Access Compliance Report

Public Rights-of-Way

(Pedestrian Signals)

Intersection ID: N/A	Main Street:	Cross Street: N/A	Location: N/A
ADA ID: 1DEC9A4FC40C	Signal Type: One Push Button-Non APS	Overall Compliance: No	Severity Score: BTN 1: N/A BTN 2: N/A No BTN: N/A
Codes/Mitigation Info/Possible Solution		Field Measurements/Component Compliance

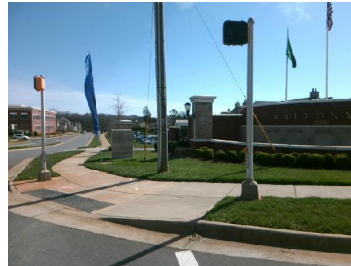
PROW/ADA: R404.2, R404.3, R404.7.3, R404.7.2

Possible Solutions: Remove and Replace Clear Space.
